September 17, 2025

Our Project No.: AA22-163A

**Re: 73-79 Sideroad 19, Fergus (WrightHaven)
Environmental Impact Study Comment Response - NRSI & GRCA**

Figure No: **1**

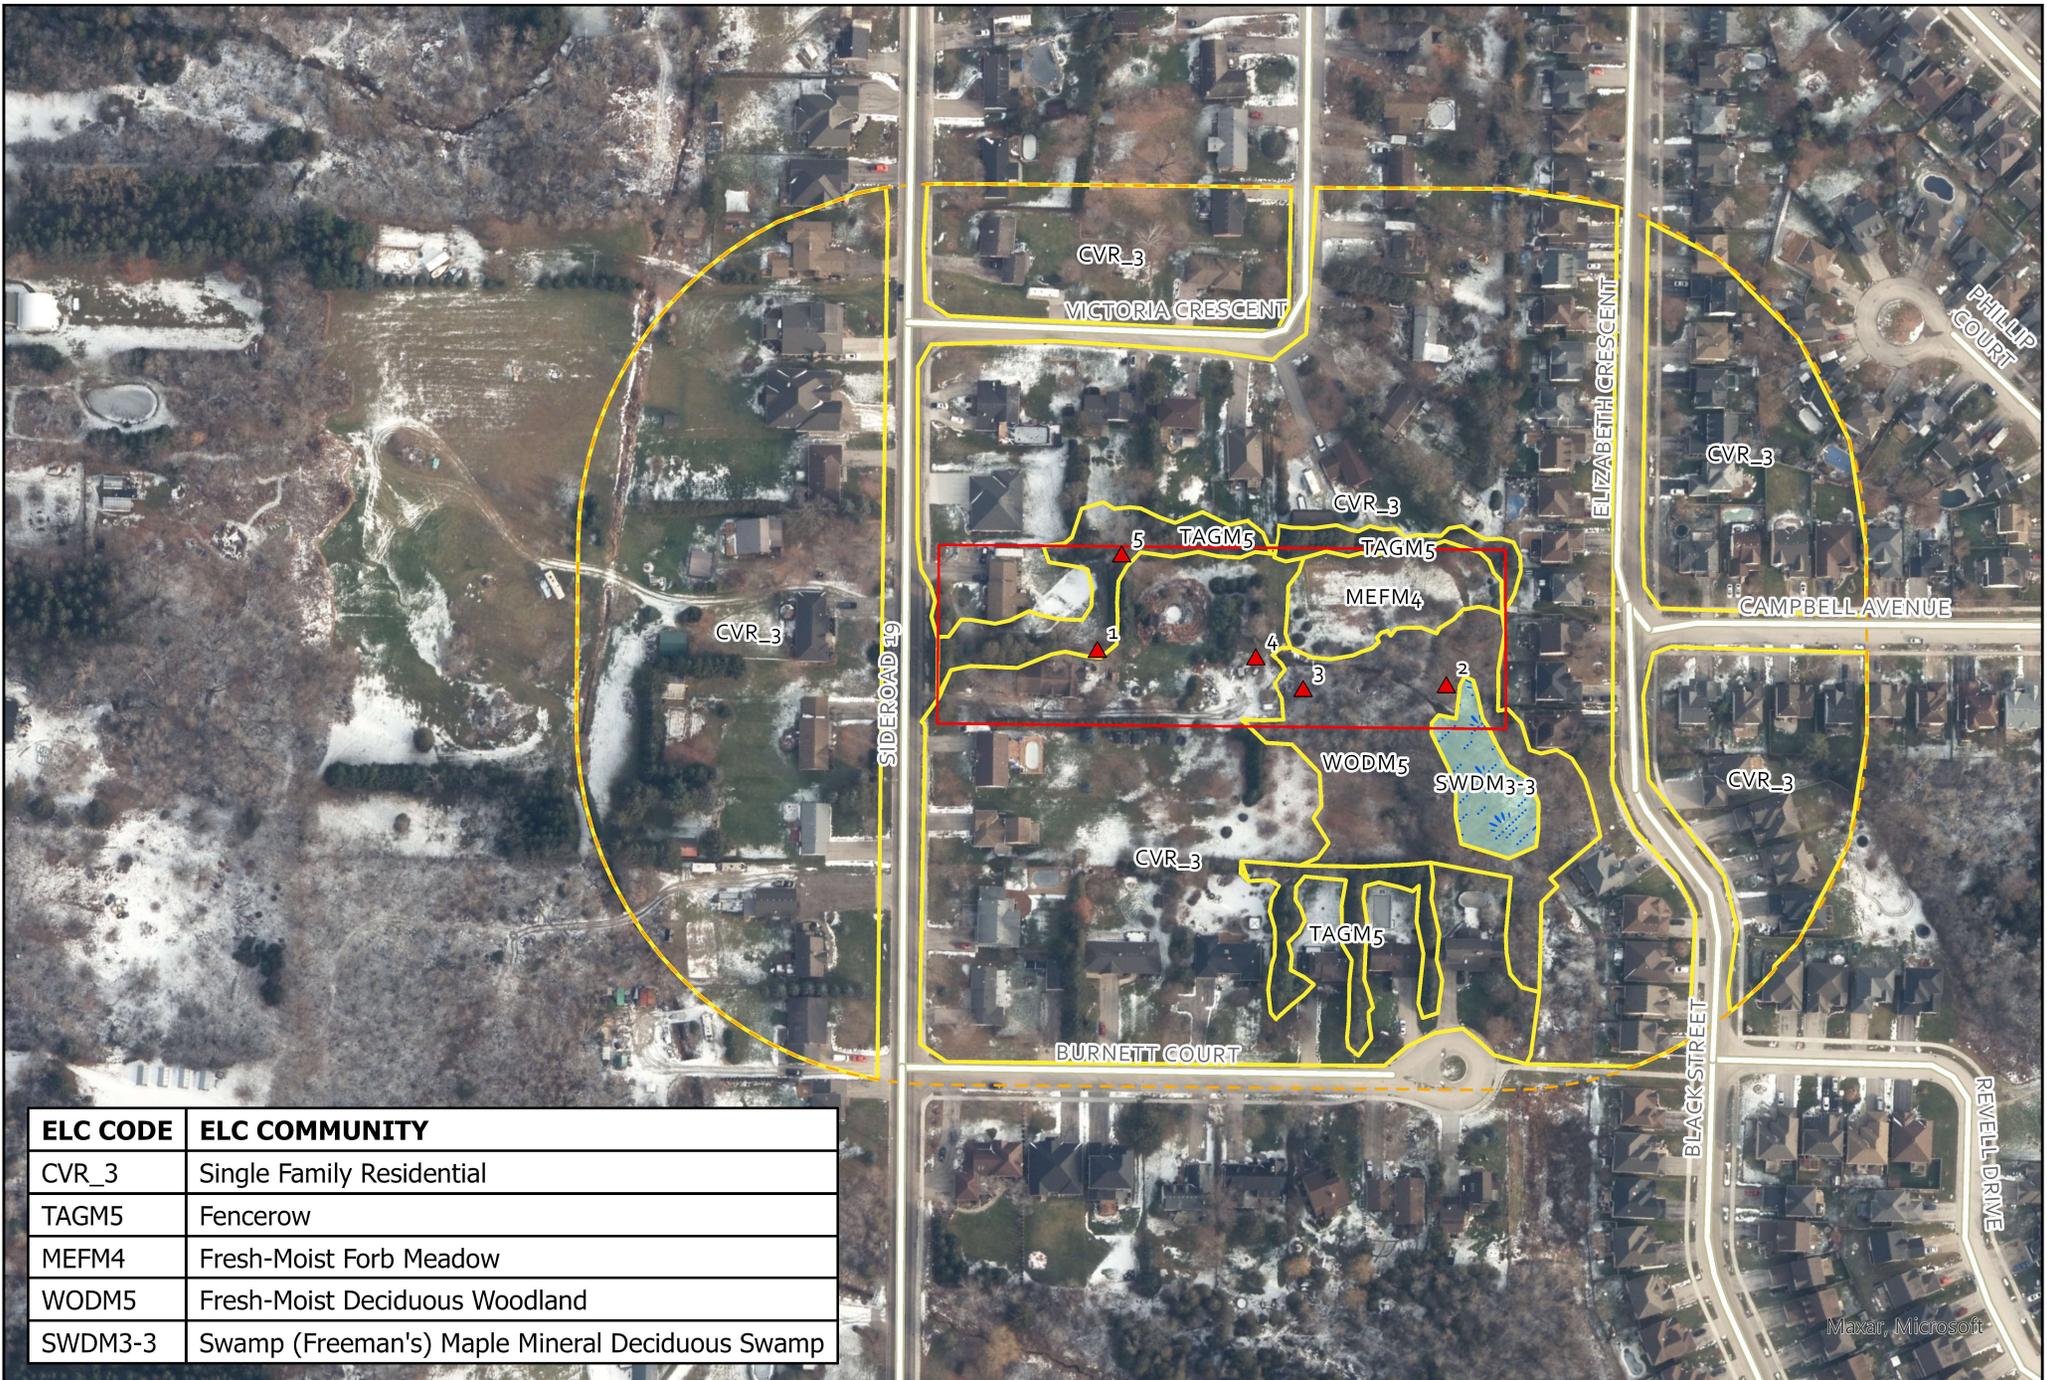
3.2	<p>Page 6 of the EIS states that a “thorough walk-through of each suitable vegetation community identified above, where access was provided, was performed” to investigate the potential for bat maternity habitat. While individual candidate roosting trees have been identified in Figure 3 of the EIS, this mapping does not identify the vegetation communities in which these trees have been recorded. It is unclear as to whether this investigation included all treed features within the subject lands. All treed features that may be impacted by the proposed development should be assessed for potential roosting habitat for bat SAR. This includes isolated trees and smaller treed vegetation communities. Confirmation that habitat investigations for SAR bat habitat considered the entirety of treed features that may be impacted by the proposed development should be provided.</p>	See response for Comments 3.2-3.6

3.4	<p>Once the entirety of the identified Candidate Bat SAR habitat has been identified, a more fulsome impact assessment can be completed, including the identification of the area of habitat to be removed. This assessment should include an assessment of the area of bat habitat to be removed in comparison to available bat habitat in order to confirm whether the removal of potential bat habitat may still be considered limited.</p>	See response for Comments 3.2-3.6

The appended *Figure 1* displays the limits of the ELC communities as well as the locations of the suitable bat maternity habitat trees. The appended *Figure 2* shows the proposed site plan and the locations of the identified potentially suitable bat maternity habitat trees. Per *Figure 2*, all suitable maternity habitat trees within the property limits, apart from Tree #2, are to be removed to accommodate the development.

As noted in Section 3.1, potentially suitable roost trees are proposed for removal; however, Per the MECP guidance document for Treed Habitats, the vegetation community types are unsuitable for SAR Bat Maternity habitat. Further, the criteria noted as present in Table 5 of the Scoped EIS is marginal with most trees only exhibiting one characteristic and all cavities being at heights lower than 10m. Additionally, high quality maternity habitat is identified as habitat with >10 snags per hectare. The total snags per hectare for the Woodland and Swamp communities were 1.75 and 8.8, respectively. Based on these results, bat maternity habitat is highly unlikely to be present within the subject lands and removal of the marginally suitable trees will not impair or eliminate any functional habitat that supports bat life processes and will not fragment any linkages or habitat, as the features are isolated within a rural residential area. As a precaution we are recommending marginally suitable trees within the Deciduous Woodland and Fencerow be removed within appropriate timing windows.

As noted above, Tree #2 was geolocated incorrectly and was within the Deciduous Swamp. However, the development will not remove trees within the wetland feature and therefore this tree will not be negatively impacted.
